APPLICATION FOR PERMISSION UNDER SECTION 16 OF THE TOWN PLANNING ORDINANCE (CAP. 131)

- 1.1 The applicant seeks planning permission from the Town Planning Board (the Board) to use Various Lots in D.D. 107, Kam Tin, Yuen Long, New Territories (the Site) for 'Temporary Place of Recreation, Sports or Culture (Hobby Farm, Fishing and Prawning Ground, Barbecue Site), Shop and Services and Holiday Camp with Ancillary Facilities for a Period of 3 Years and Associated Filling of Land' (proposed development) (Plan 1).

(S.16 Planning Application No. A/YL-KTN/1049)

Figure 8.7 - Chart for the Rapid Design of Channels

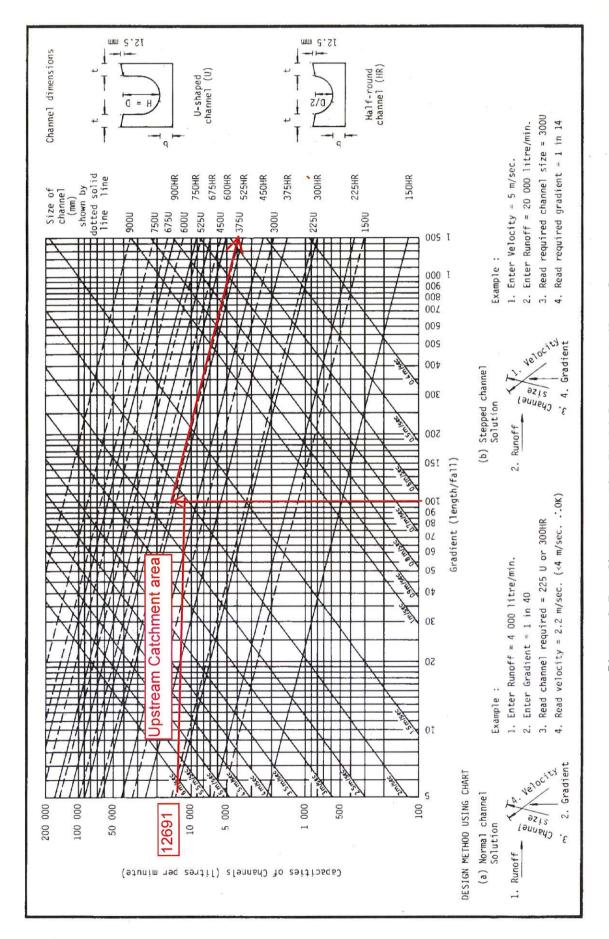
(b)	GEO Technical Guidance Note No. 43 should	GEO Technical Guideline Note No.43 is
	be adopted for u-channel checking as Figure	adopted.
	8.7 of the Geotechnical Manual for Slopes	17
	(GCO, 1984) was superseded.	w , ,

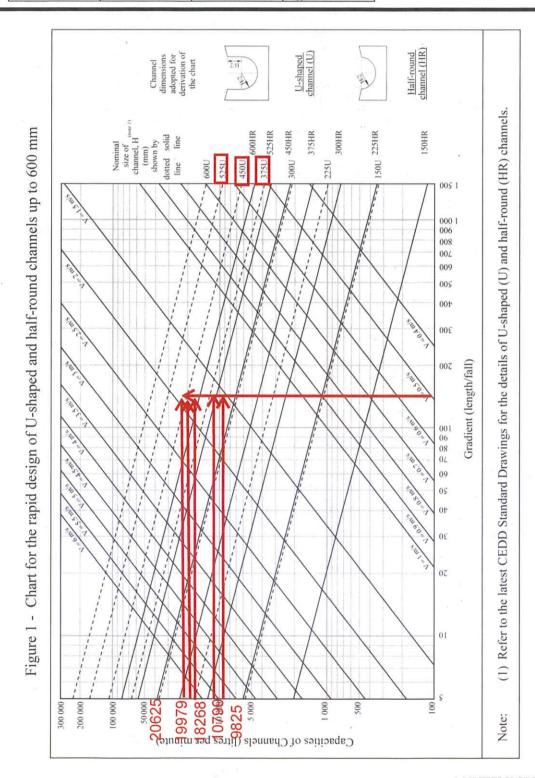
(e)	Checking for 600mm dia. pipe - Please review the rainfall intensity and SDM Corrigendum Nos. 1/2022 and 1/2024 should be considered. The rainfall intensity should not be identical with the one for application site as time of concentration is different. The outlet discharging pipe appears to be undersized. Please review and refer to our comment no. 6 below.	It is revised accordingly.
